NO.: 04 TS – 30 (REVISED)
July 22, 2004

TO: All Distributors/Dealers and Their Branches
ATTN.: Service Managers
FROM: David J. Mester
SUBJECT: **MBE 900 - Allison Transmission Shift Delay**

(This letter replaces the 04 TS – 30 version released June 10, 2004.)

MBE Engine Torque Dropout

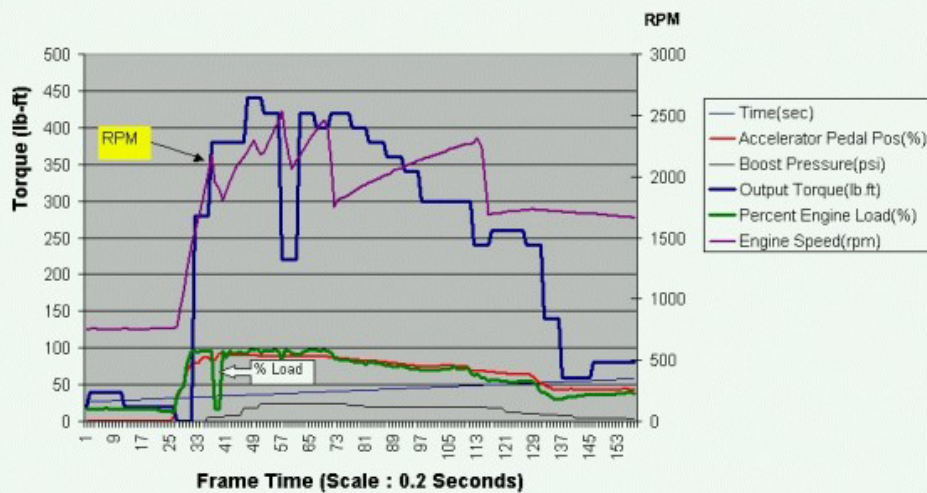
The symptoms experienced by the driver are an engine hesitation and loss of power during the one – two up-shift, (Figure below). In addition, the transmission up-shift point going from two to three is influenced, but lacks the severity of power loss as recorded between the one - two up-shift.

The snapshot data in the above figure was extracted from a Thomas Bus with the 3DL electronic tool. It identifies a momentary loss of requested engine torque, followed by the significant loss of engine speed during the one - two up-shift for a period of approximately 0.5 seconds.

DDC Electronic Engineers discovered a critical calculation was omitted after the release of VCU software version 14.19, which caused the requested torque to drop approximately to zero therefore creating the up-shift concern.

The field concern can be resolved by using either the Mini-Diag or the DRS station and changing the following Vehicle Control Unit (VCU) parameter group:

1. Group 23 \ Limiter II
2. Click: Parameter # 35 \ Acceleration Limiter During Shift
3. Change setting from 1 to zero

This parameter setting is used with the Allison 4000 Heavy Duty Transmission equipped with the acceleration limiter. The above procedure will deactivate the feature and allow the Allison 1000, 2000, and 3000 Transmission to shift properly without harm to the MBE 900 Engine or Allison Transmission. The software calculation has been corrected by DDC Electronic Engineers and will be released to VCU software version 14.20.
